PART NAME: **ALIGO TMS VERTICAL SAFETY WIRE ASSEMBLY**

SYSTEM: **ADVANCED LIGO** SUB-SYSTEM: **AOS**

SIZE: **B** DWG. NO.: **D1100827** REV.: **V4**

EXPLODED VIEW

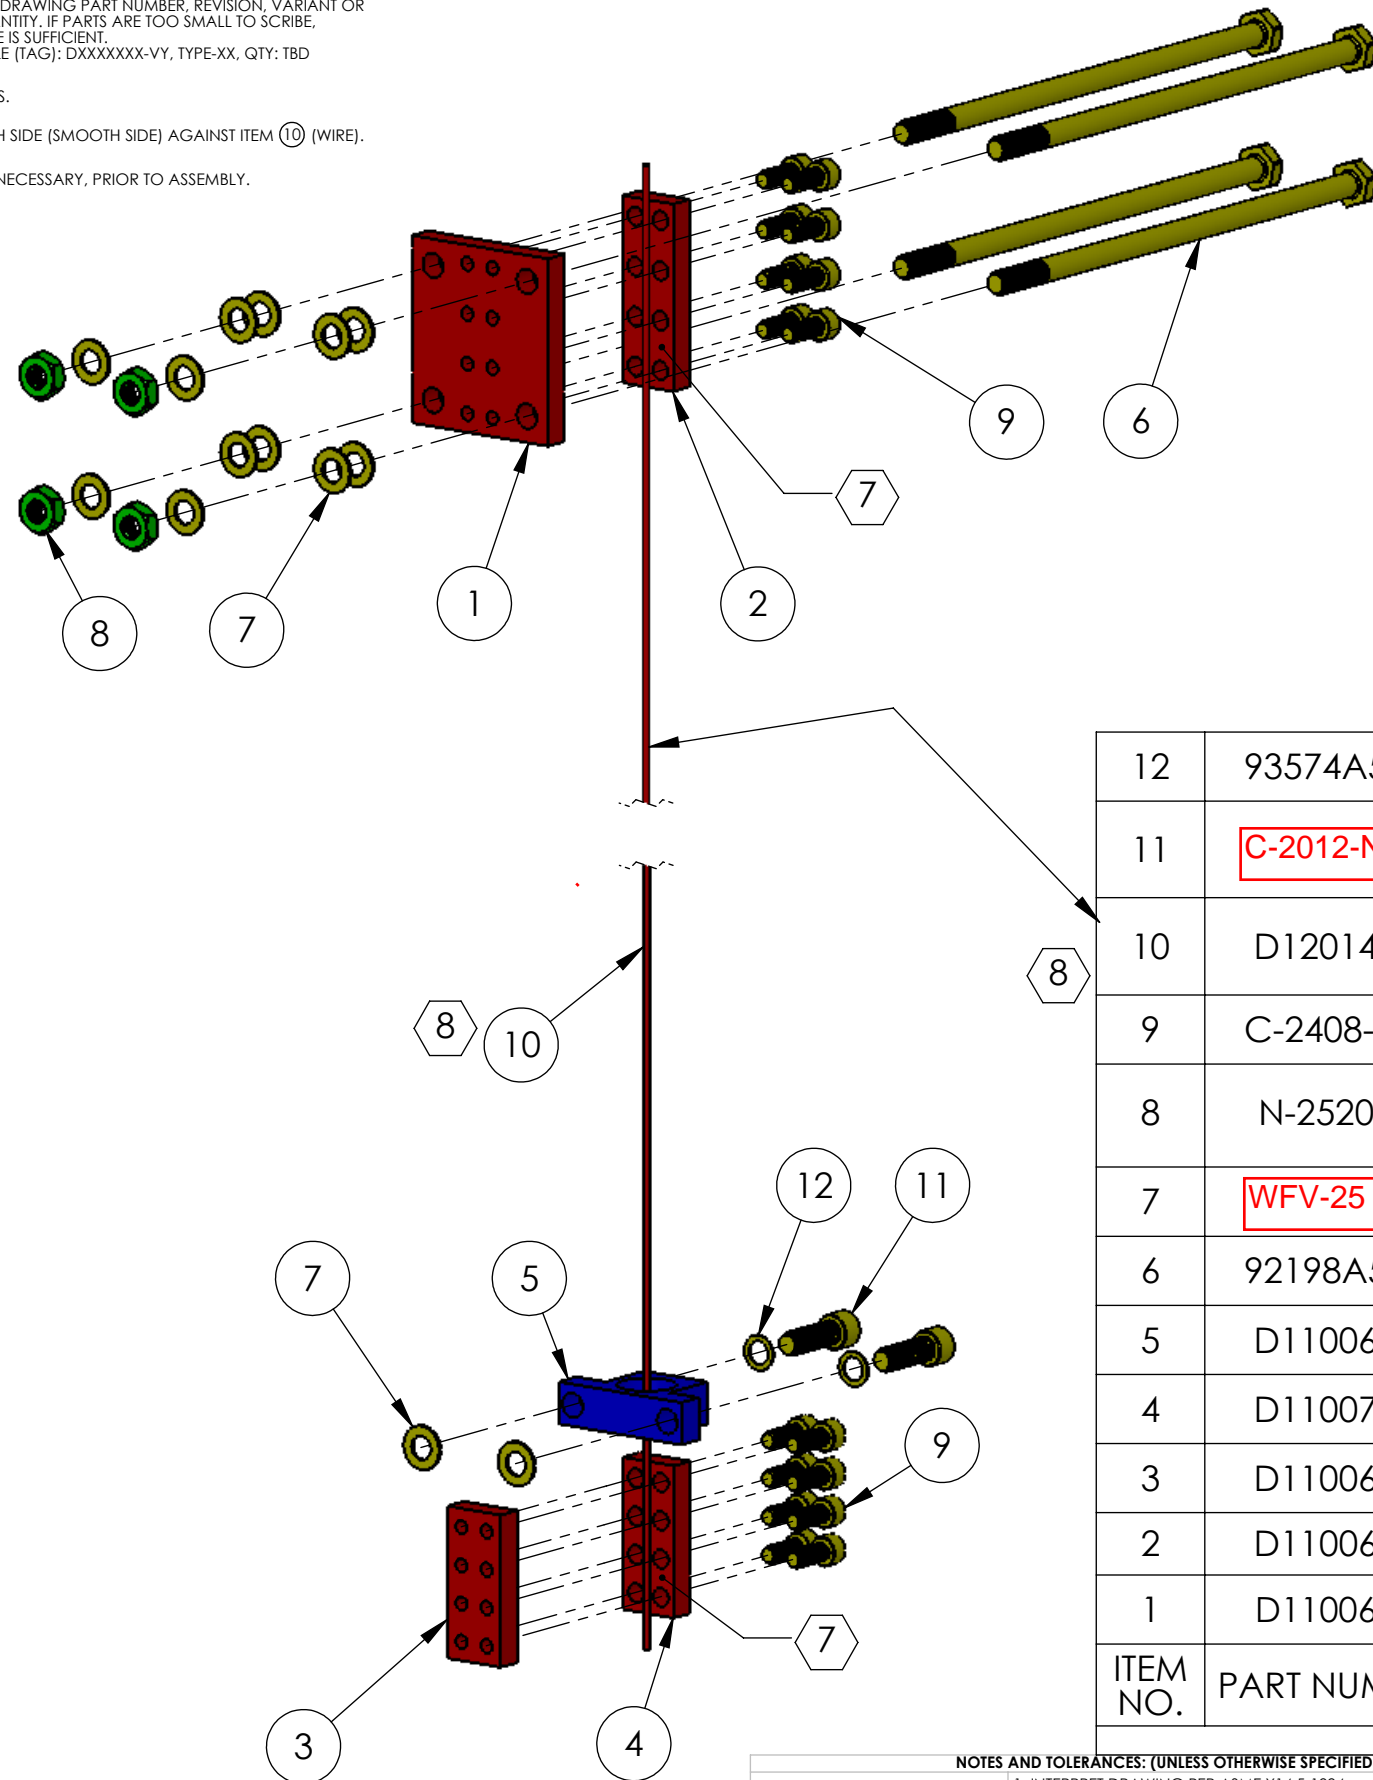
SEE RED LINE V2 IN DCC

NOTE:
Item 10
MUSIC WIRE FOR FIRST ARTICLE,
PRODUCTION IS 316 Straight Stainless Stl.
